**CONTAINMENT LINER TEST CHANNEL
AT
BEAVER VALLEY POWER STATION - UNIT NO. 1**

MARCH 1, 1979

**PREPARED BY
STONE & WEBSTER ENGINEERING CORPORATION
for
DUQUESNE LIGHT COMPANY**

FIGURE 6
 DOME - SECTIONAL ELEVATION
 CONTAINMENT STRUCTURE
 BEAVER VALLEY POWER STATION - UNIT NO. 1
 DUQUESNE LIGHT COMPANY

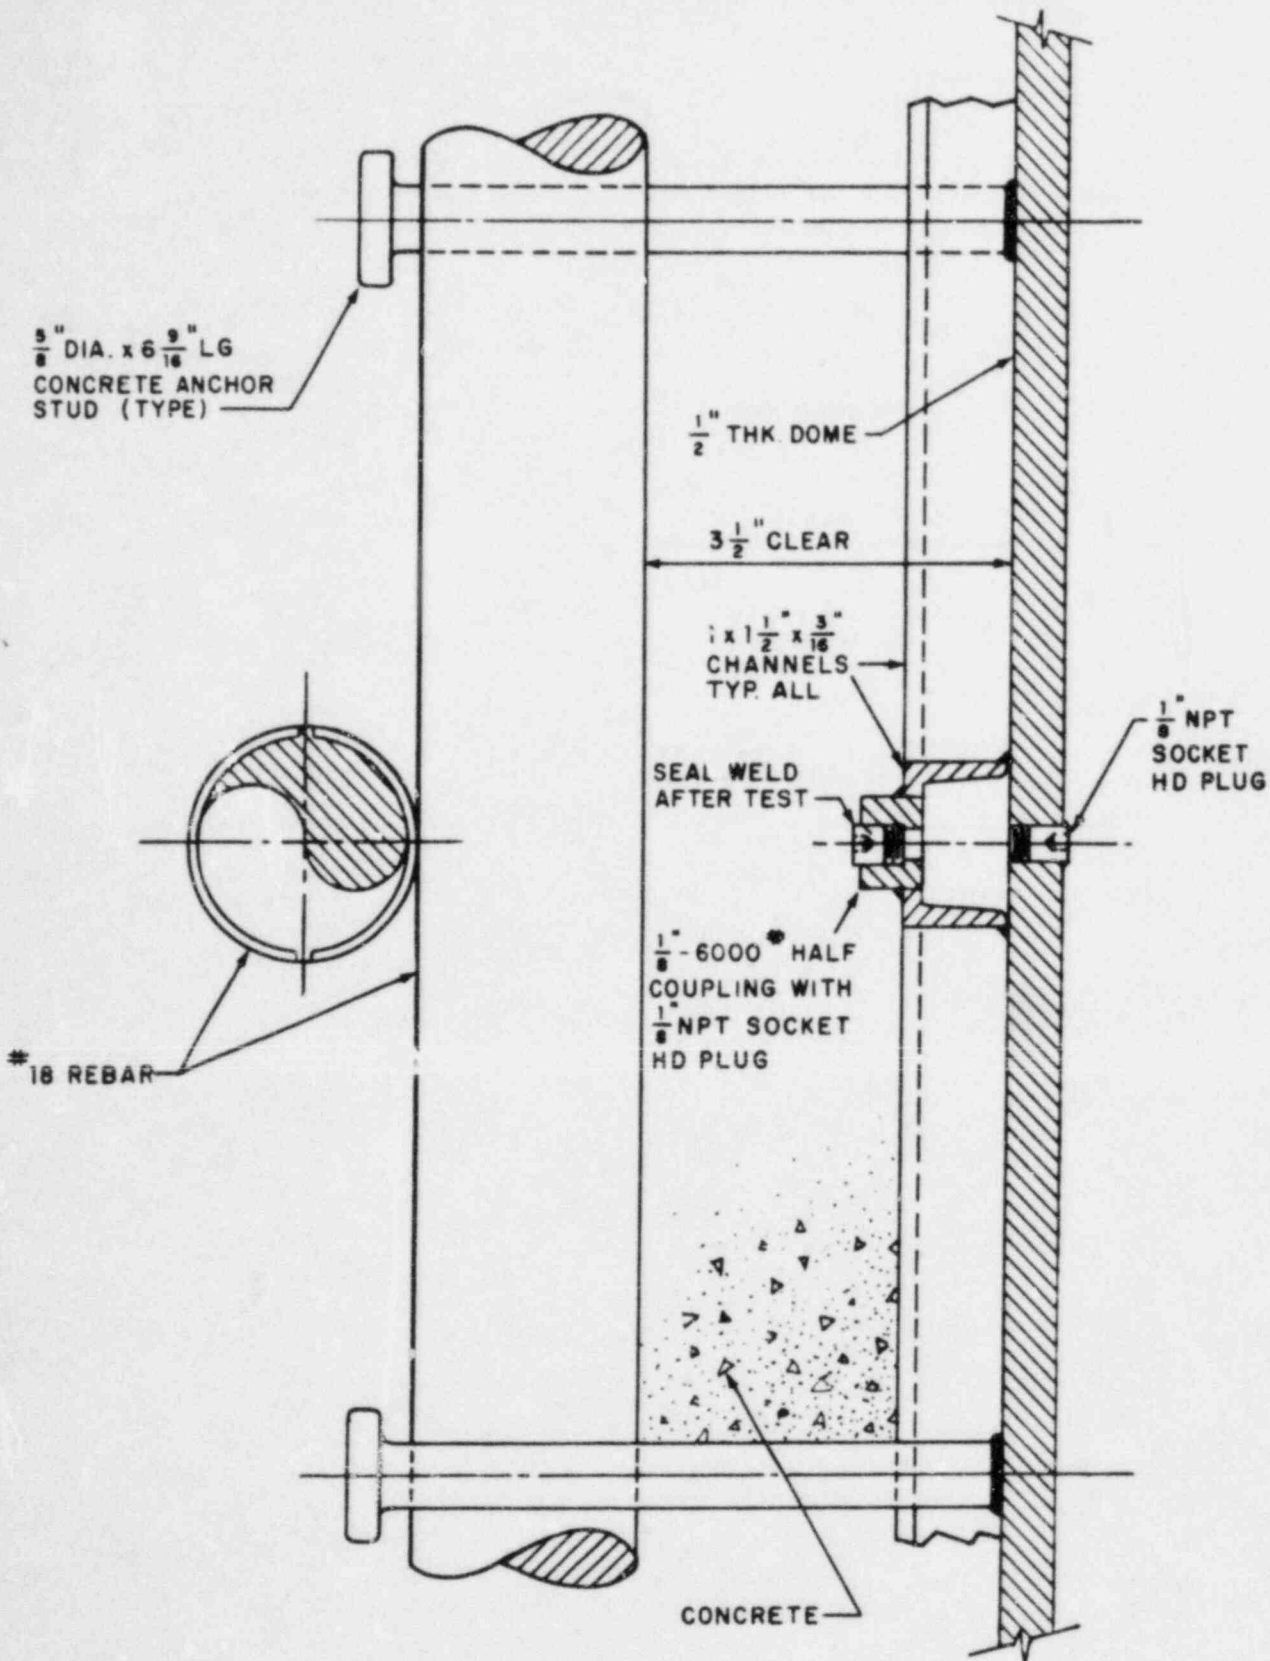
B.1 Materials Identification and Construction
Description

Provide as-built descriptions and drawings of the dome channel details specifically the plug assembly in the liner seam welds. Provide construction assembly procedures and address the immediate surroundings of the channel boxes on the exterior of the liner. Provide the basis for assuring these channel welds will hold against the shear forces if the liner moves against the concrete structure.

To further quantify the adequacy of the dome test channel welds to the containment dome liner (Figure 6) for shear forces which may exist between the liner and reinforced concrete structure, a horizontal ring of dome liner was isolated and the forces acting on this ring identified as indicated in Figure 8.3. The limits of the ring were chosen to be midway between adjacent horizontal dome test channels. Forces identified as acting on this ring segment are:

B.1 Figures 3c, 4 and 6 illustrate the details of the dome test channels.

FIGURE 7
 EFFECT OF pH ON CORROSION
 OF MILD STEEL
 CONTAINMENT STRUCTURE
 BEAVER VALLEY POWER STATION-UNIT NO. 1
 DUQUESNE LIGHT COMPANY

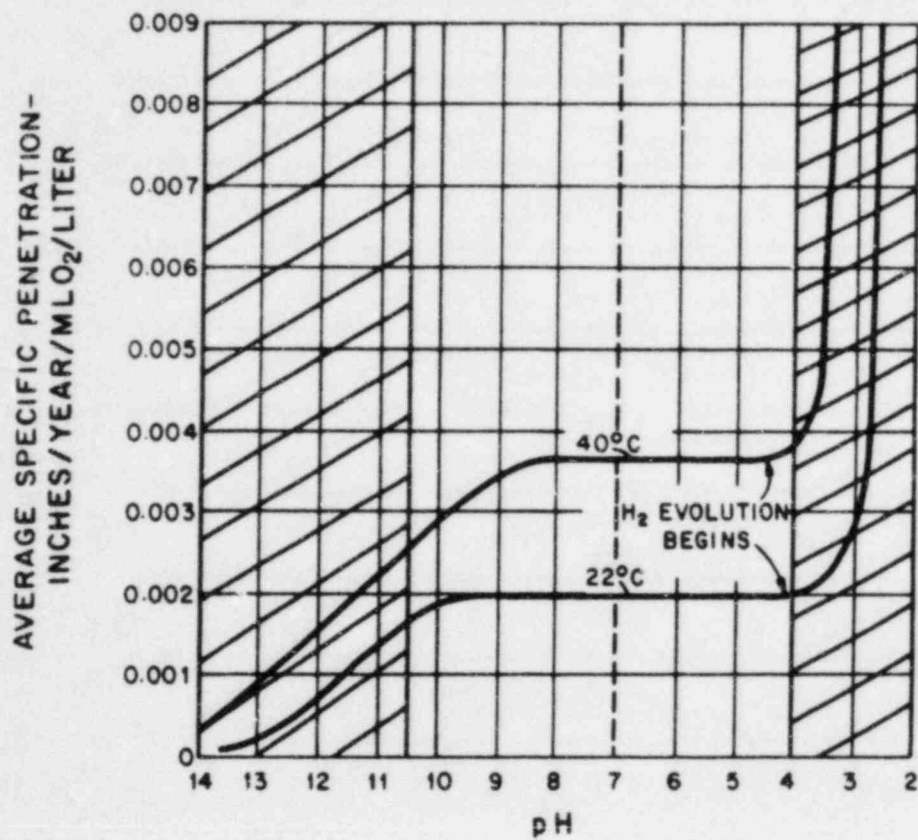
A.5 Condensation and Corrosion Inside Boxes

For plugged boxes with an undetected failed box weld or loose plug, provide analysis of condensation inside the box, chemical analysis of any condensed liquid, and corrosion rates of the liner, welds and channel boxes inside the boxes.

sodium hydroxide caustic spray) to 4.2 (boric acid in the safety injection accumulators at 2,200 ppm boron concentration) are, or may be present within the reactor containment. Figure 7, extracted from Uhlig's CORROSION HANDBOOK, Fifth Edition, is a plot of corrosion rates at various temperatures versus pH. The zone of interest, with a pH ranging from 4 to 10.5, has been highlighted. The curves demonstrate that, as pH is increased from 4, the corrosion rate will either remain constant or decrease with increasing pH.
